1. Integration envelope.

Summary: integration length along Z for ECCE ECAL design should be revisited with details in comparison to a similar ALICE EMCAL design, the total full length of 42 cm as proposed needs to be understood and specified in details. The actual length required for the ECCE ECAL $18.5X_0$ may be significantly longer than specified in the presentation. More importantly, the ECAL of only $18.5X_0$ in the forward direction at the hadron endcap can also be an important issue for physics considerations and should be examined through realistic GEANT simulations.

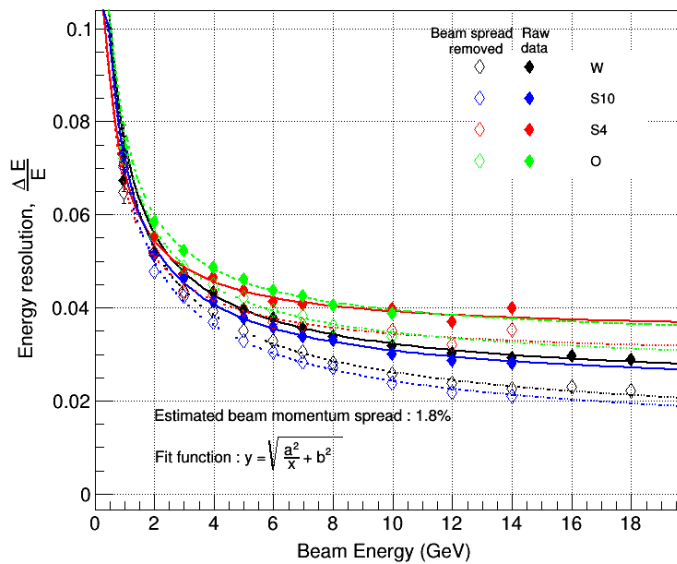
Guesstimating for ECCE readout these translates to 2.5 MeV – 30 GeV ? – please correct. (Guesstimate comes from shower profile at shower max as we have strips in STAR SMD somewhat similar in size to granularity of forward ecal, sure it is not a super accurate scaling).

For example, now the question is how many pixels one wants to see fired from 2.5 MeV? - say it is 10 pixels, which will be consistent with LY form such shashlik structure.

Then range will be 10 – 120k pixels. Proposed SiPM is S14160-3050HS as on slide, but it is probably S14160-3015?? Please clarify.

14160-3050HS has 3531 pixels – how this will match with 120K pixels fired from 100 GeV?
14160-3015 has 40k pixels – assuming that one was proposed, then one will need at least four SiPMs and still not enough.

I am totally confused with number of SiPMs and the type of SiPM to be used for readout. It is not clear how the proposed SiPM presented at the meeting will match the physics requirements in the YR. Please clarify this.

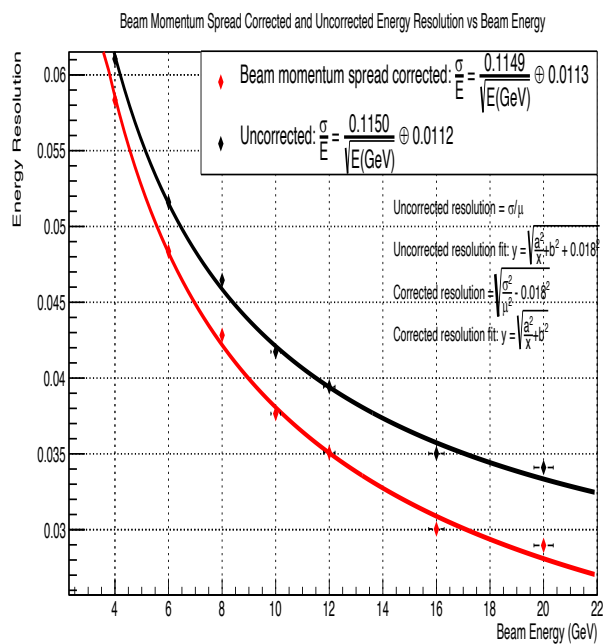
7. My previous questions related to attenuation lengths and readout upstream. We actually have experimental measurements for STAR FCS. In 2016 test run at FNAL we investigated if PHENIX ECal blocks can be used for STAR, concern was aging. Plot shown below, green open diamonds – PHENIX Shashlyk resolution, readout single large PMT per block at the back of the module. Fit parameters 7.2% stochastic, 2.6% constant were found to be consistent with PHENIX measurements at test beam.

In 2019 test run block was outfitted with STAR SiPM readout. Readout in this case is upstream. We tried to measure at higher energies, but there were issues to get higher energy electrons. Fit is not great, it is missing 16 and 20 GeV points

At lower energies there is quite a difference in resolution between these two schemes of readout. It may be attributed to many factors (there are extra dead material in PHENIX blocks if readout is upstream, but it is also may be related to attenuation curve and where shower max is sitting on this curve).

The point I am trying to make here, resolution numbers as shown in the proposal as 7.8% stochastic and 0.3% constant used for validation may be way off. A single particle simulation including as much as possible realistic module structure need to be performed and effects on resolution had to be understood.
